**CITY OF JOPLIN  
ADDENDUM NUMBER 2**

Date: 1/10/2020

Project Name: **City of Joplin Trail and Pedestrian Bridge STP-3201(705)**

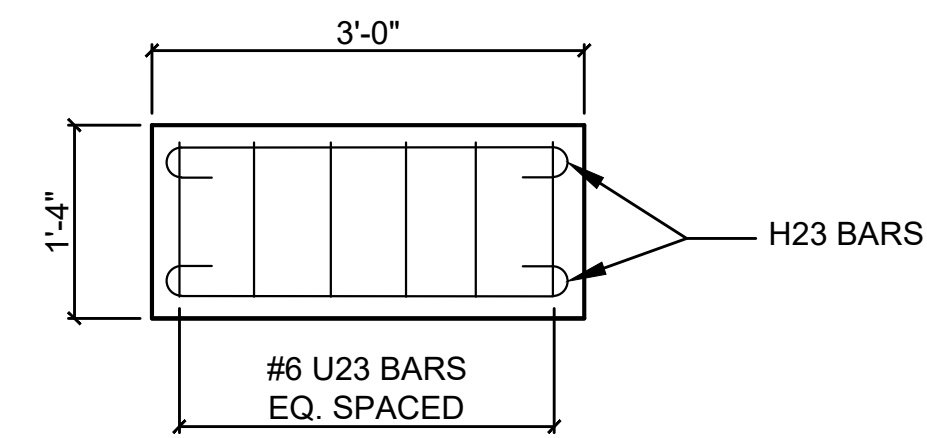
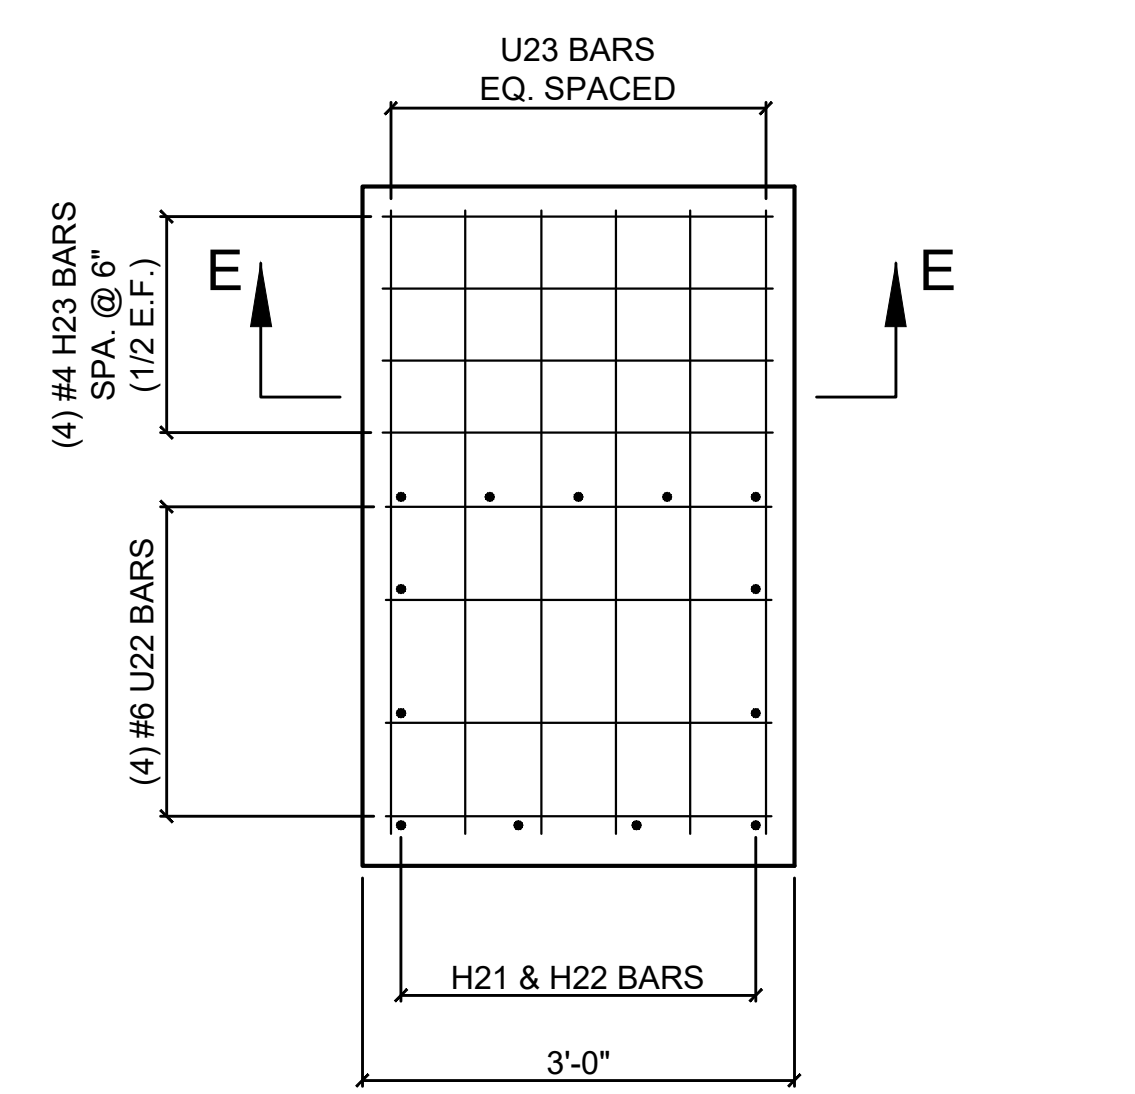
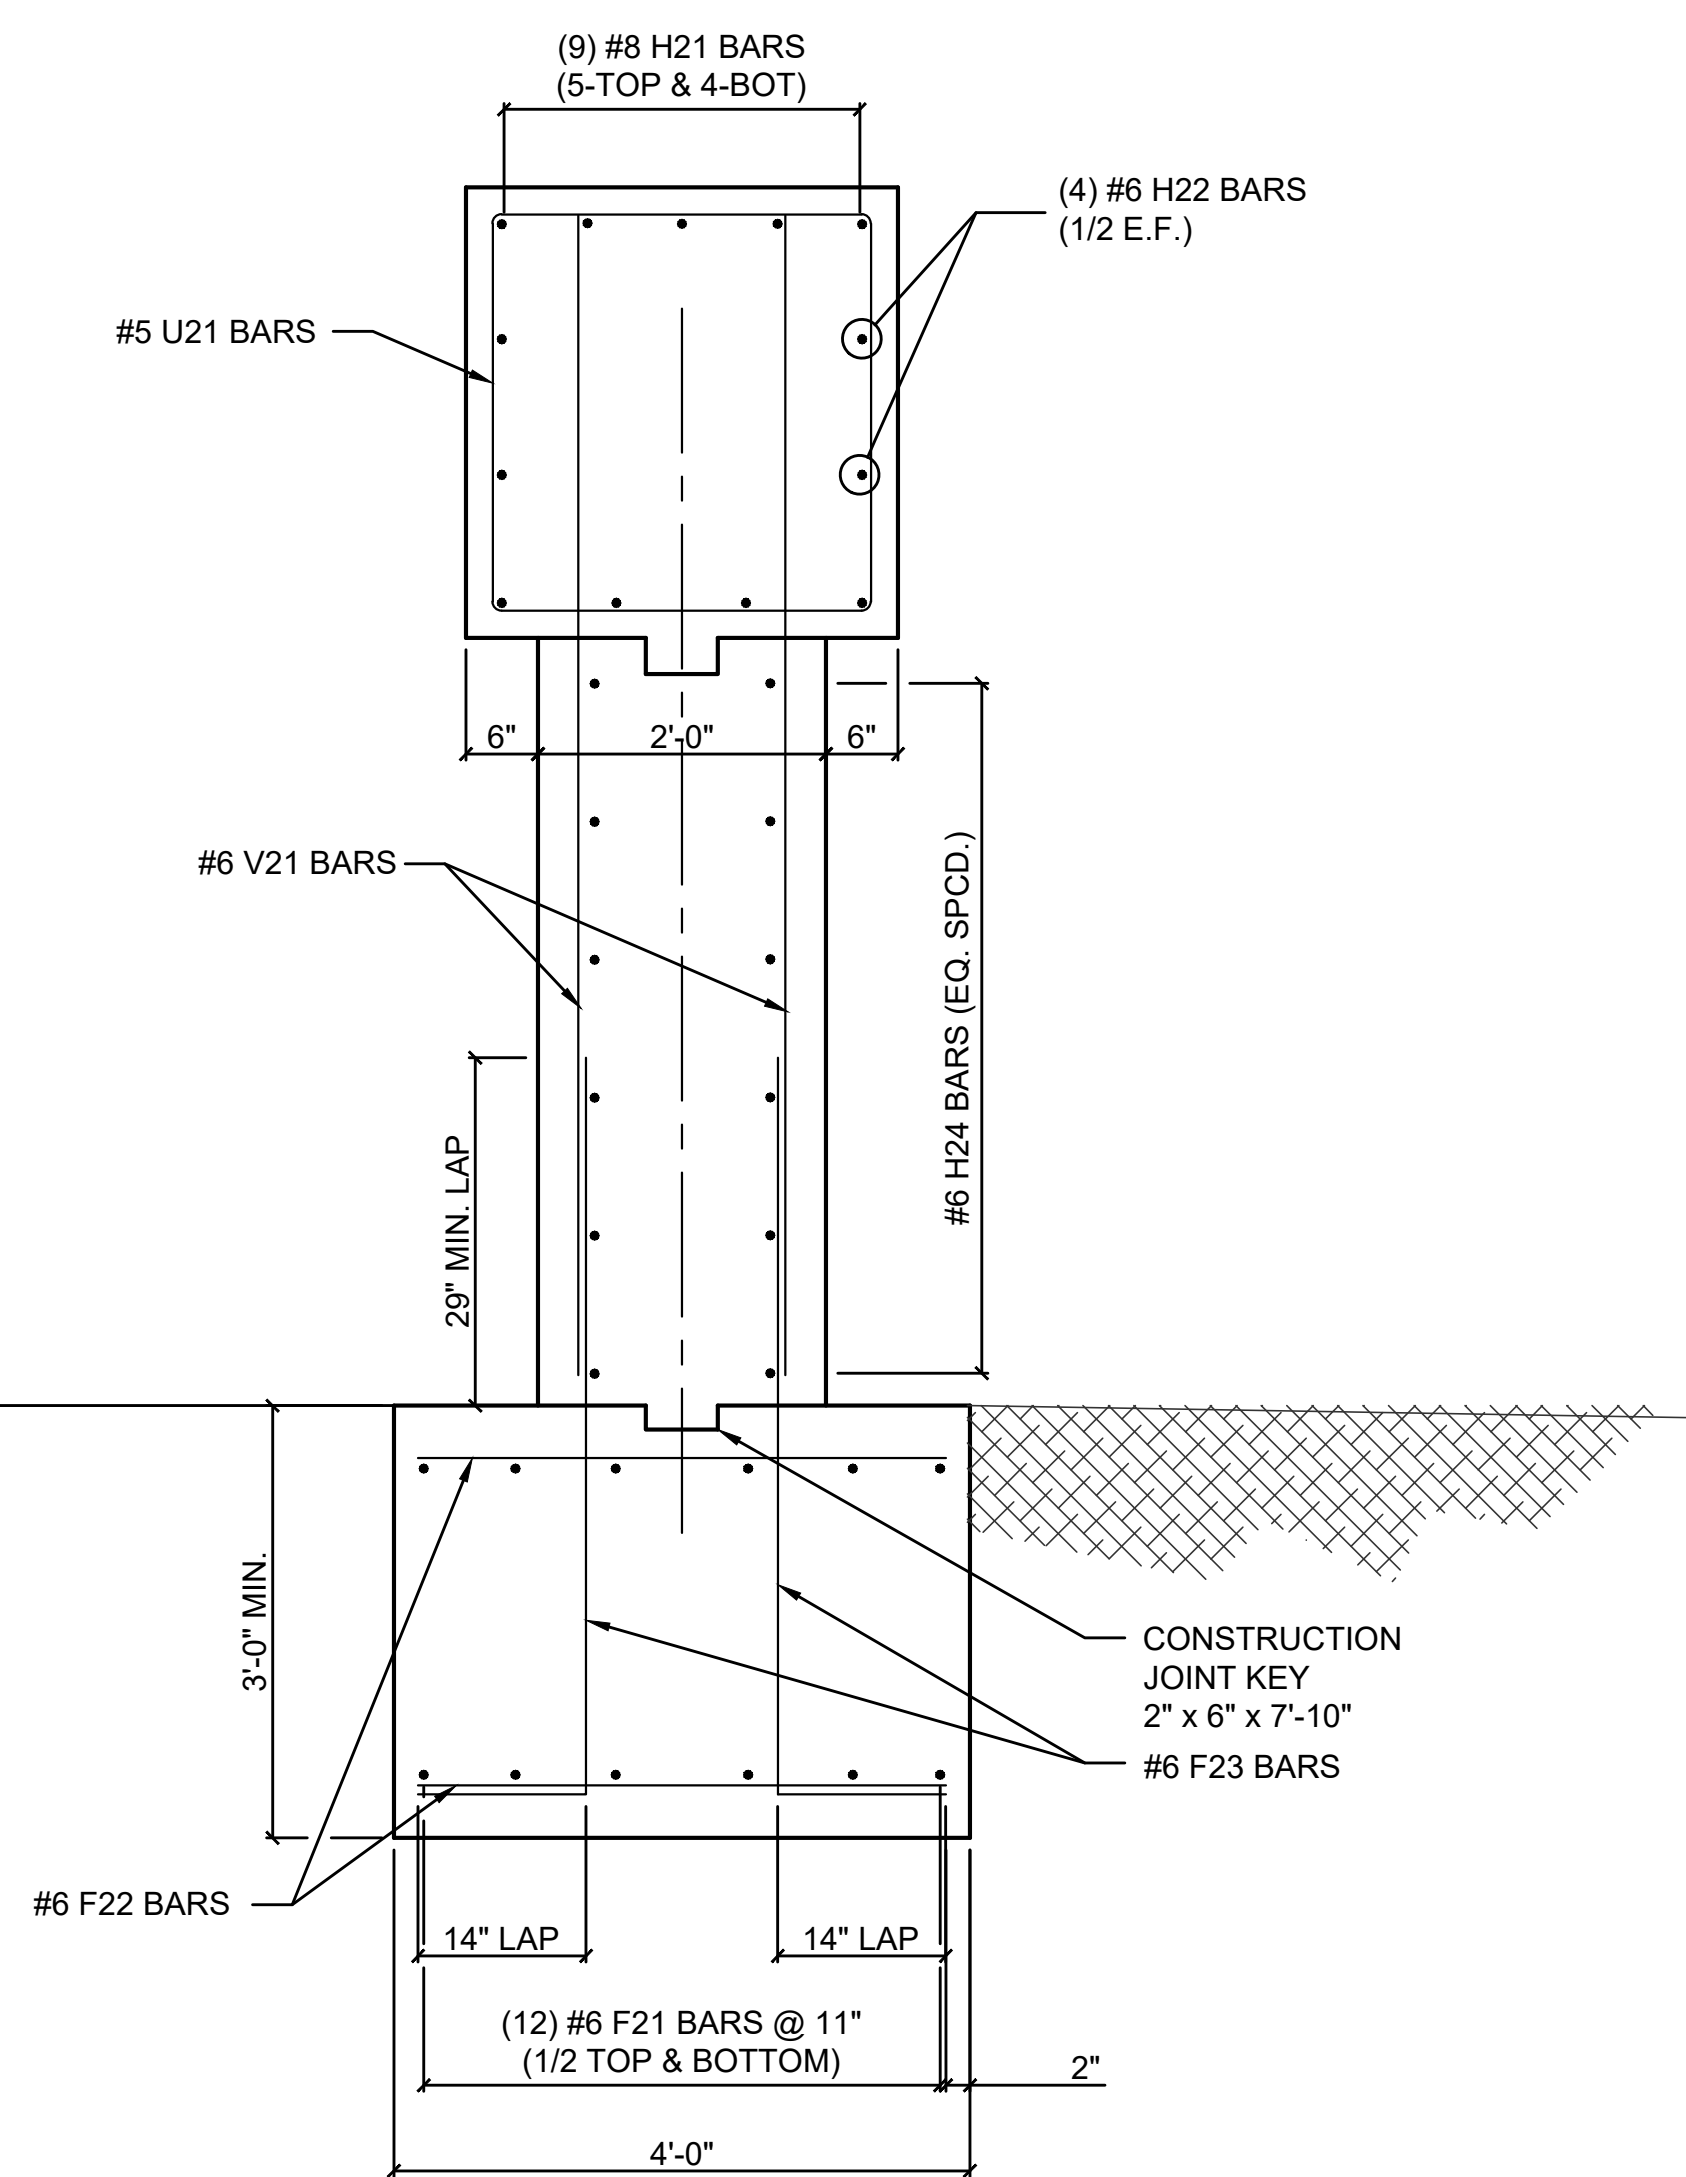
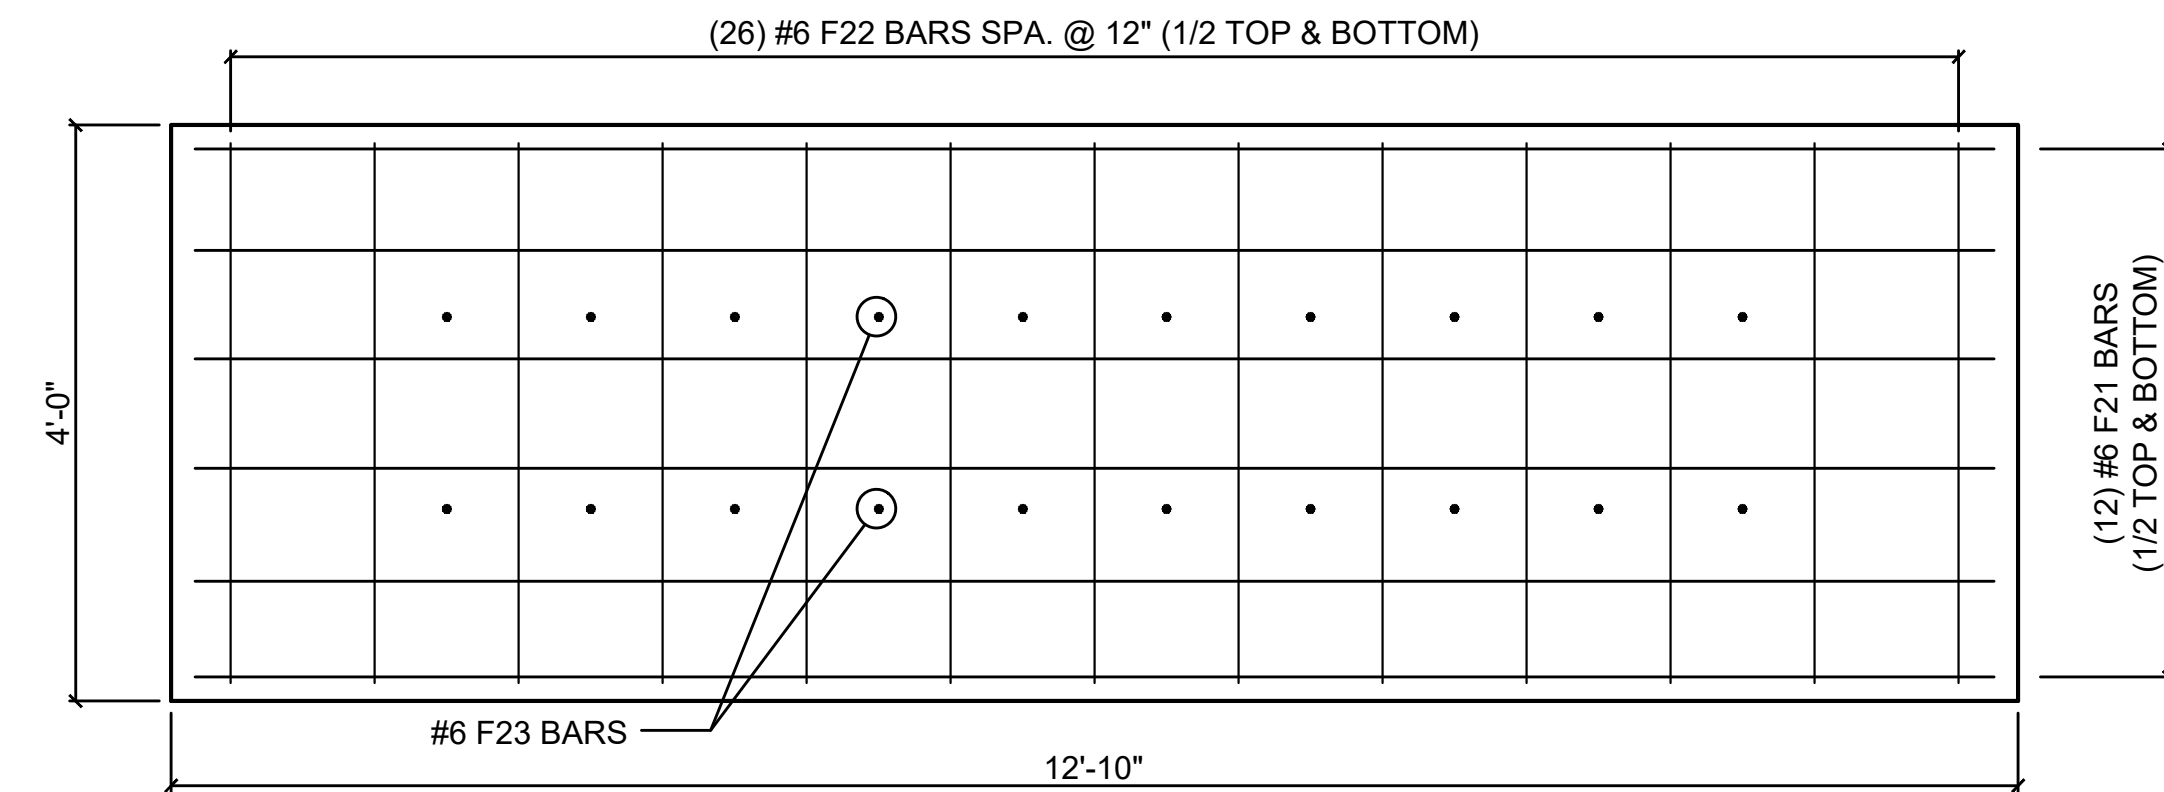
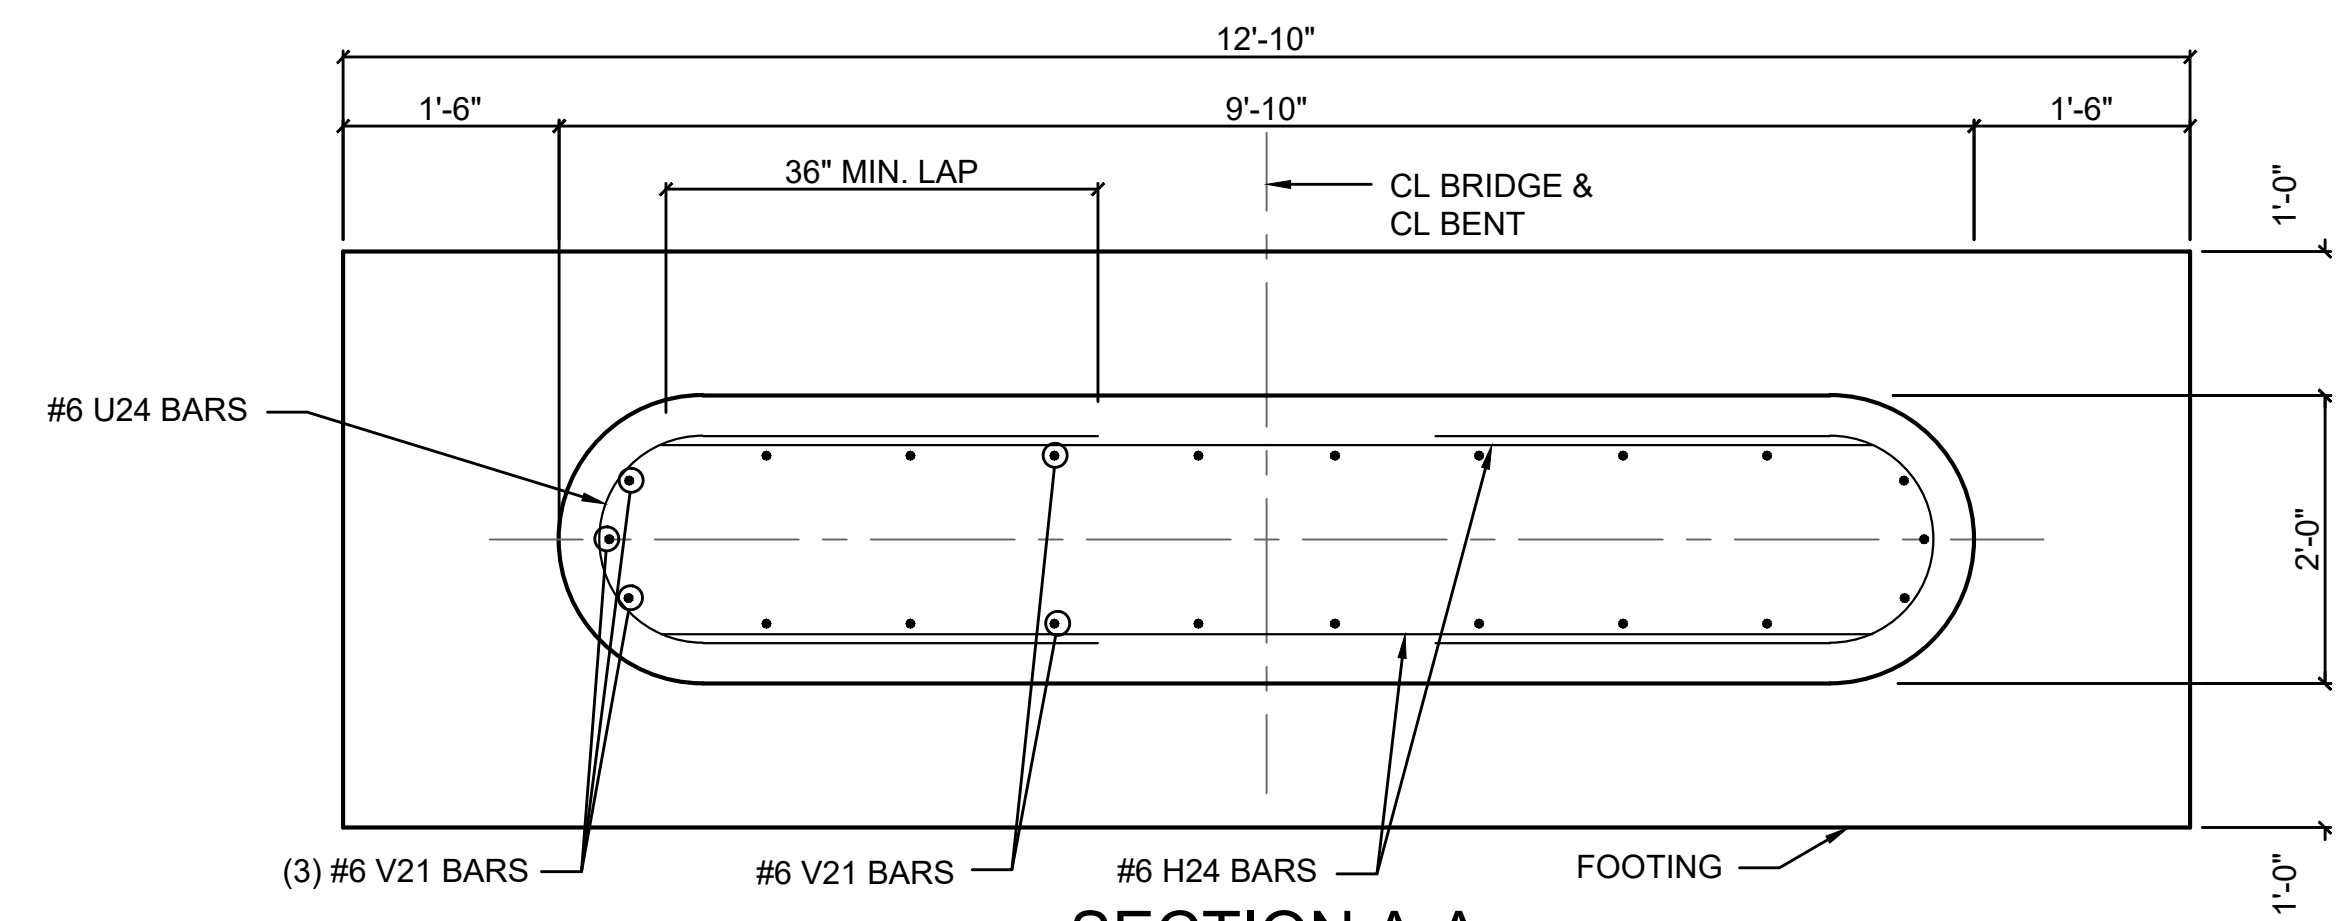
3. Multiple bridge plan sheets have been revised to include the addition of a modified concrete corral rail with pipe rails. The location of the stone veneer columns at the corners of the bridge has been revised as well.
